SUBJECT: Switchboard Review, for "City of Imperial" project, in Imperial, CA

Enclosed is one copy of the subject drawing, which has been stamped "Approved As Submitted". The proposed service is a 600 amperes at 120/208 volts, three phase, four-wire wye.

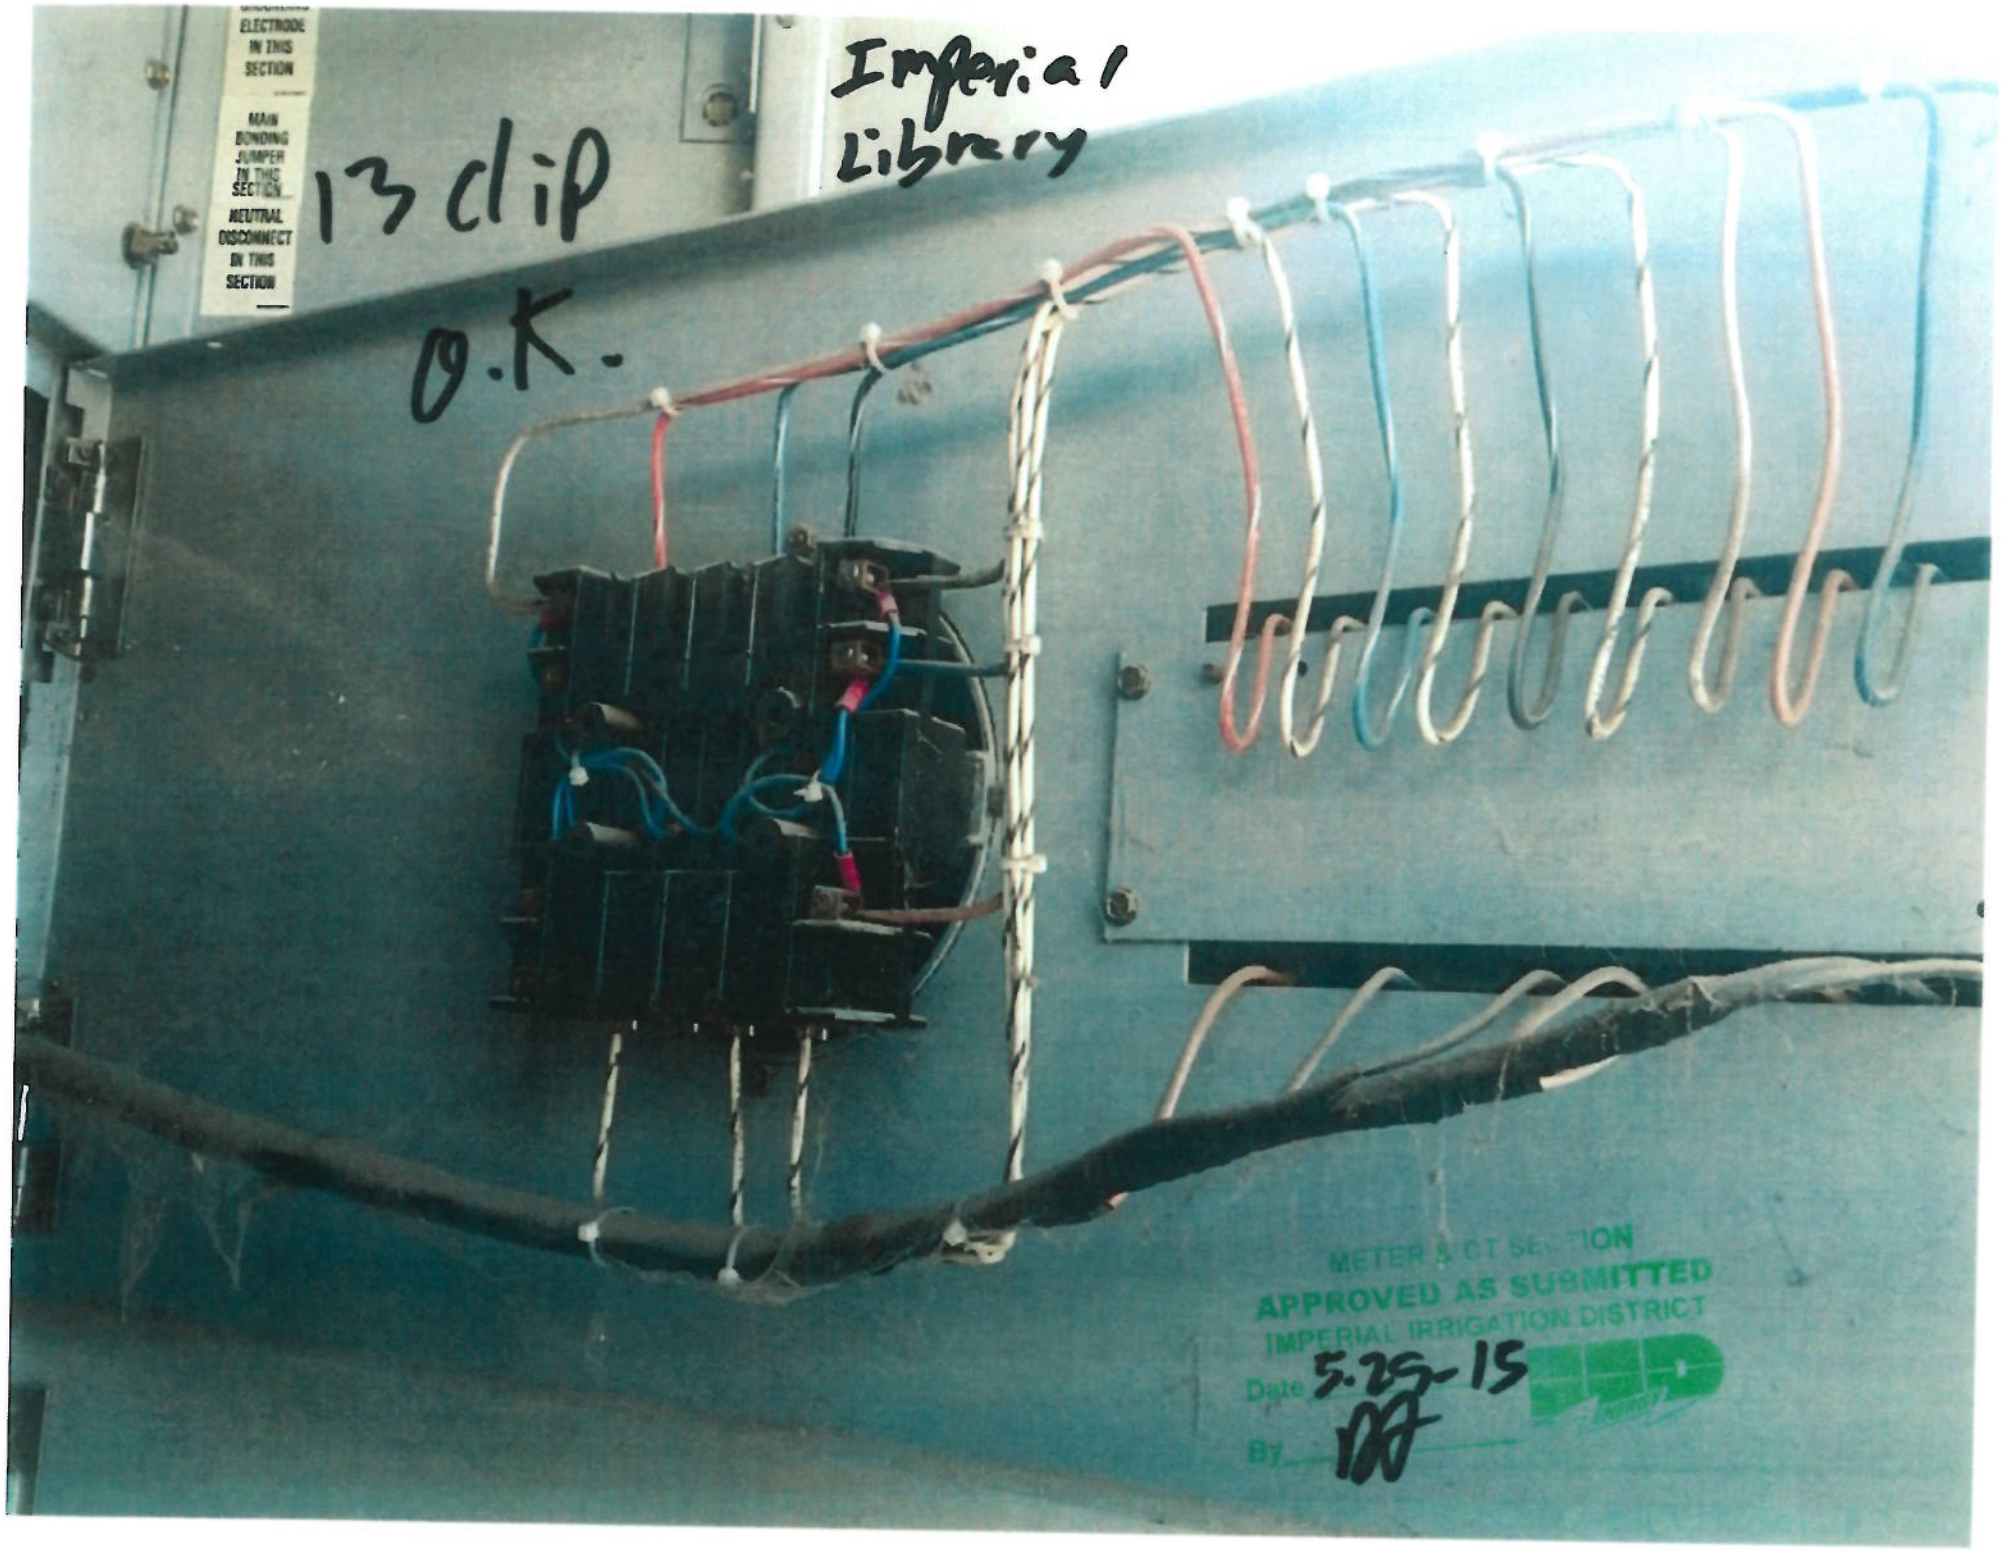
ELECTRODE IN THIS SECTION
MAIN BONDING JUMPER IN THIS SECTION
NEUTRAL DISCONNECT IN THIS SECTION
13 clip
O.K.
Imperial Library
METER & CT SECTION
APPROVED AS SUBMITTED
IMPERIAL IRRIGATION DISTRICT
Date 5-29-15
By

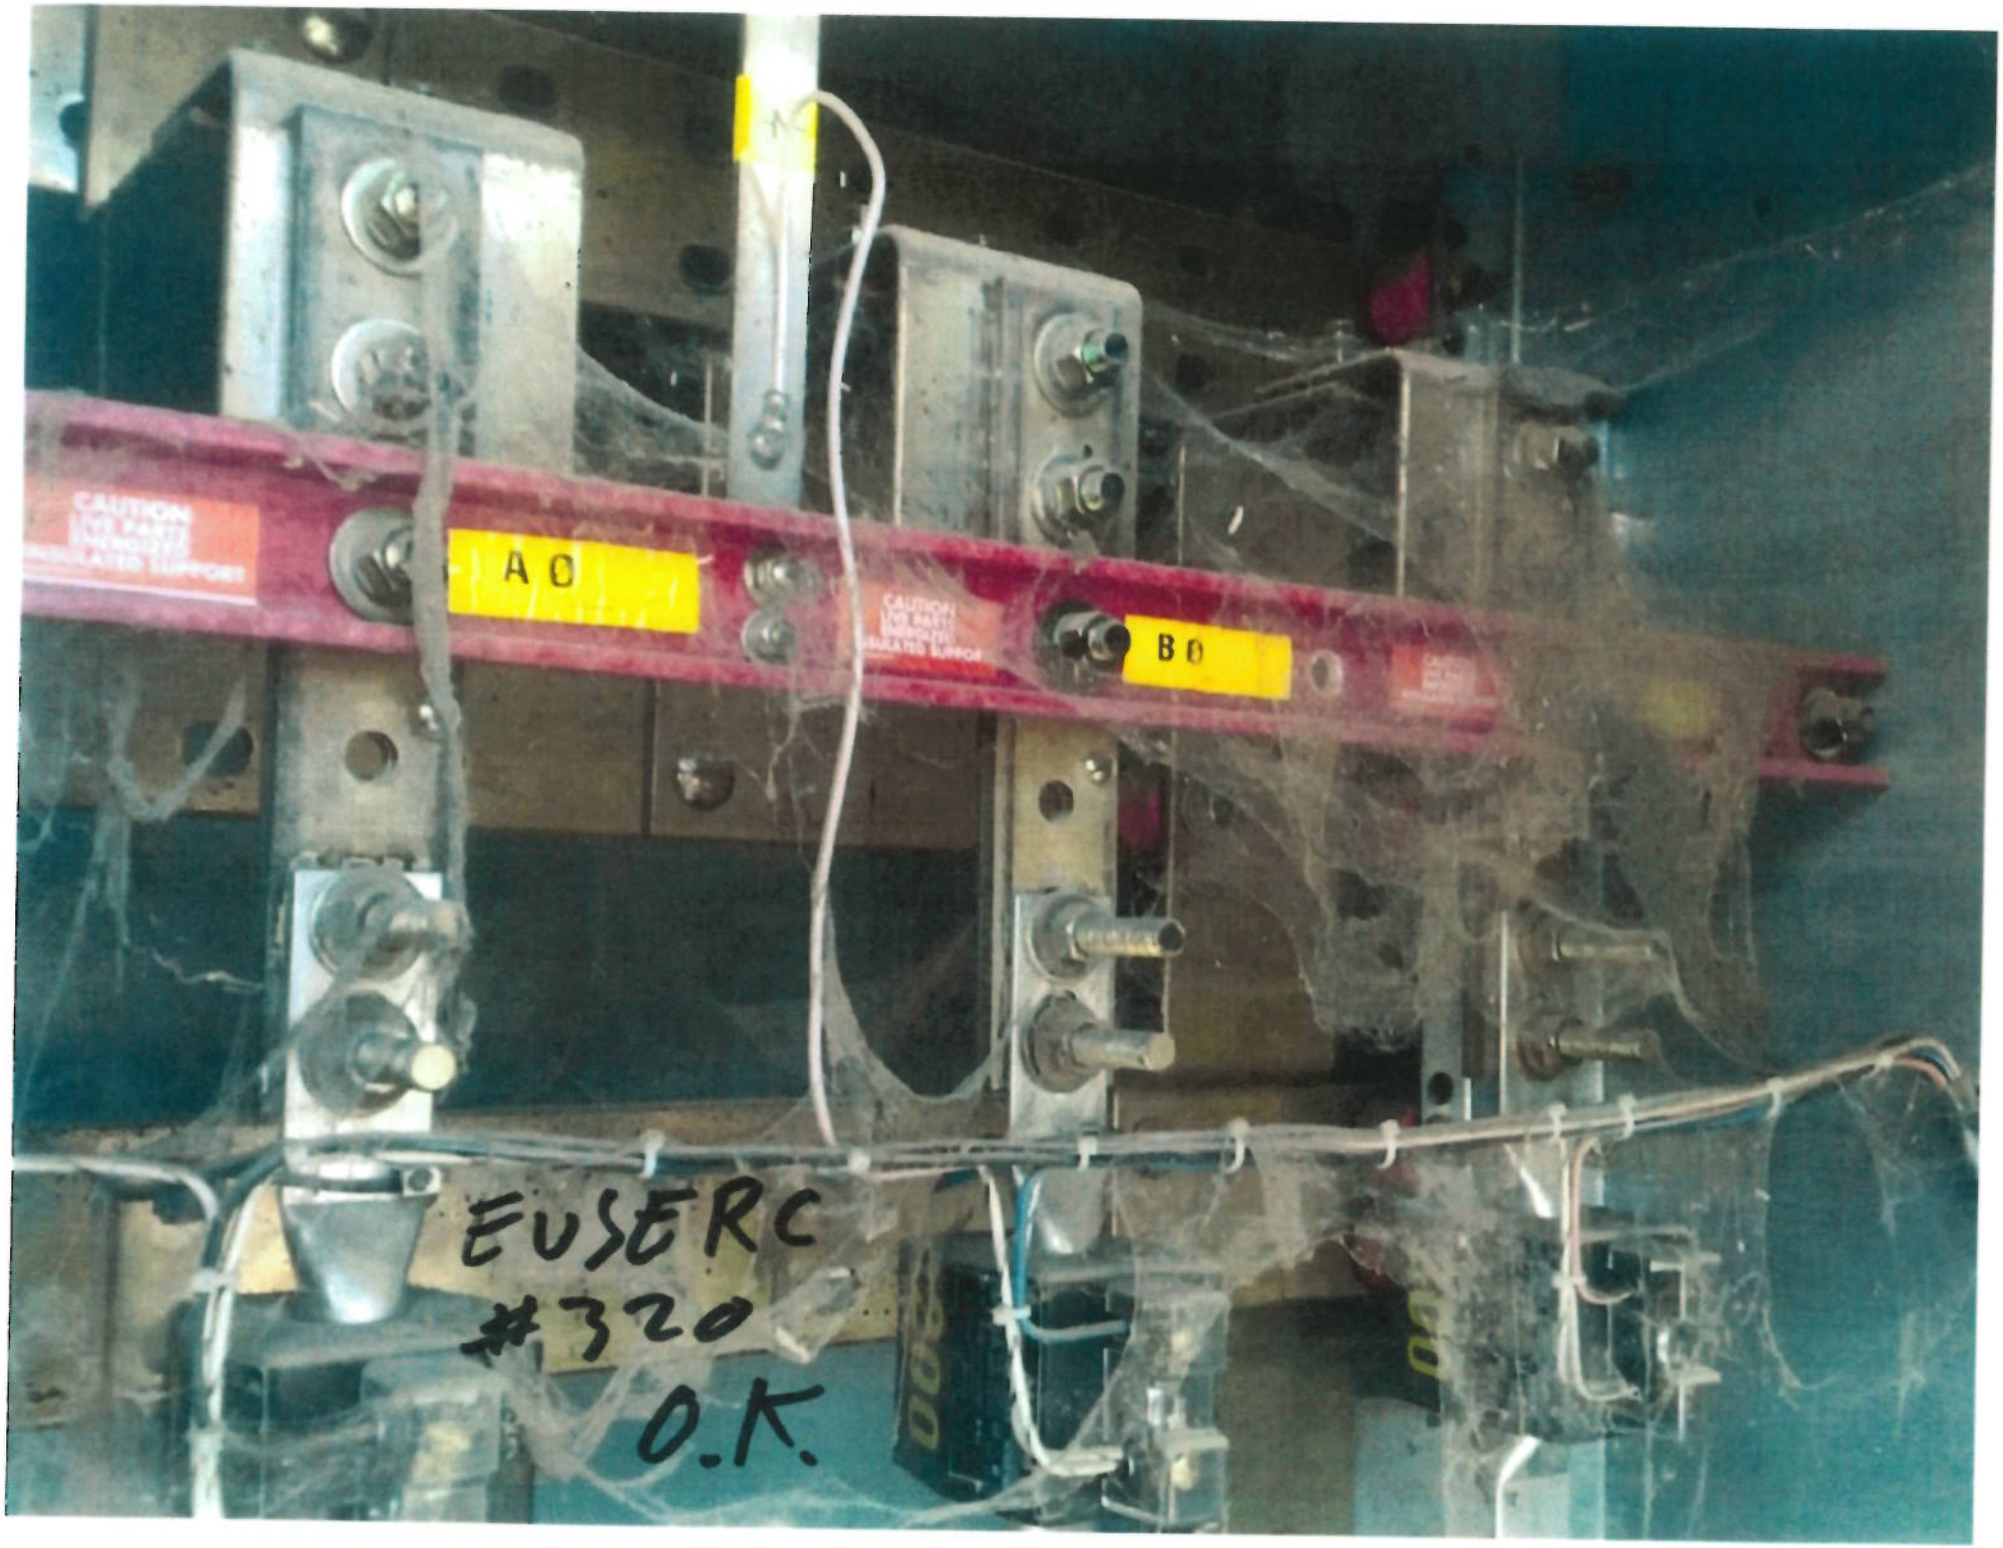
A0
B0
EUSERC
#320
O.K.

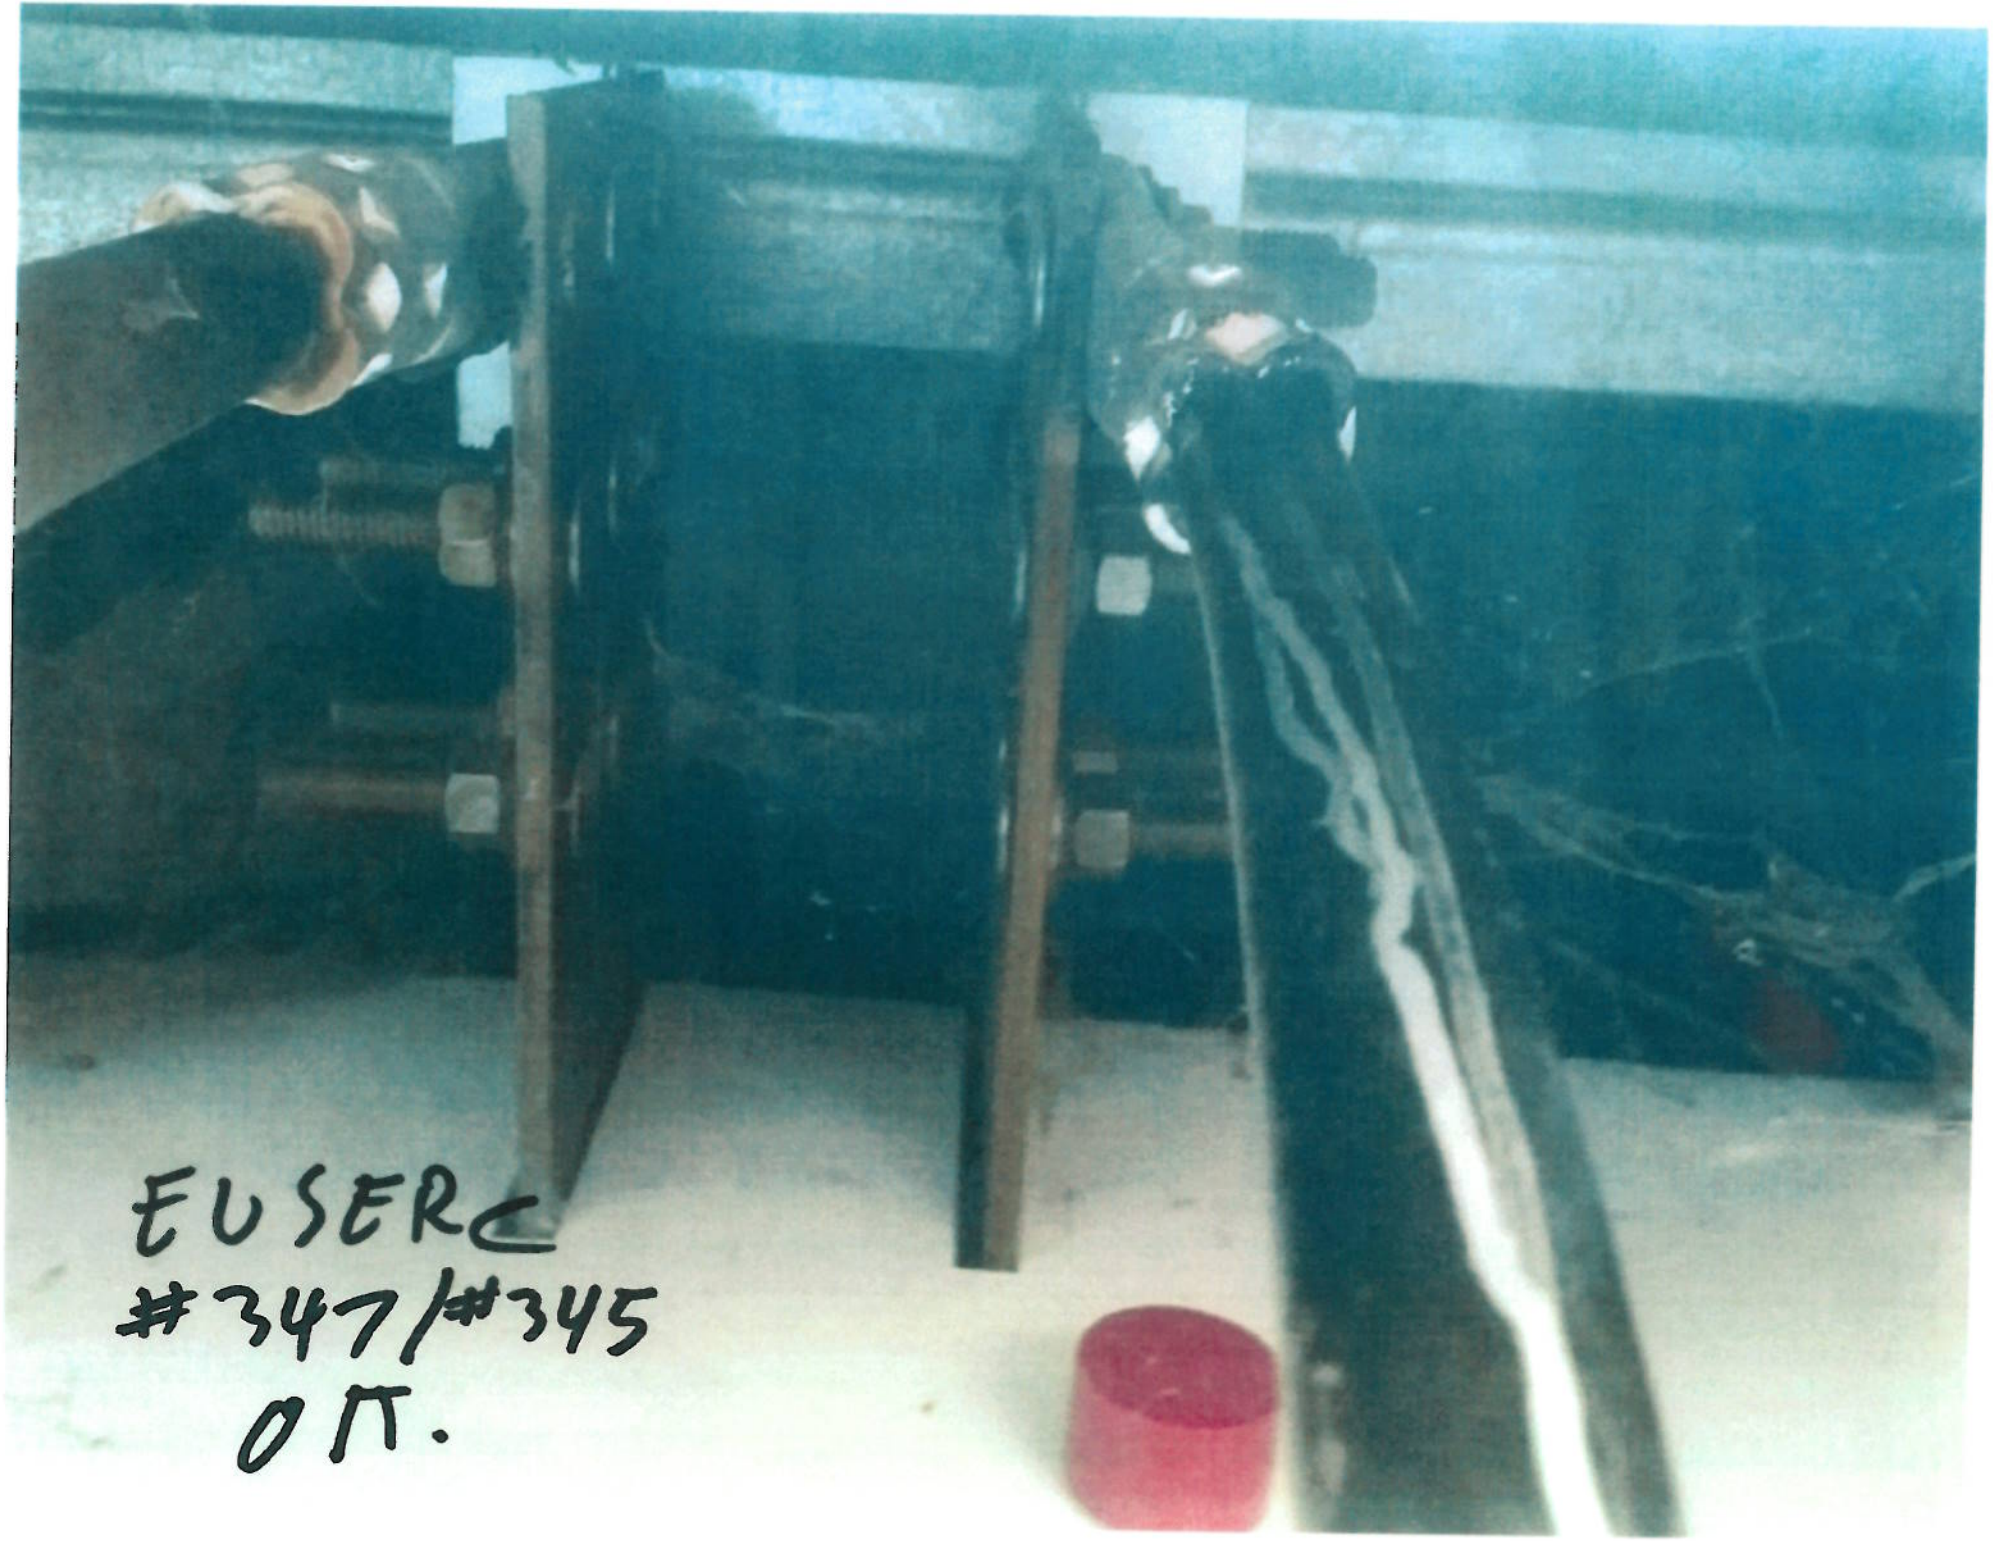
EUSERC
#347/#345
OK.
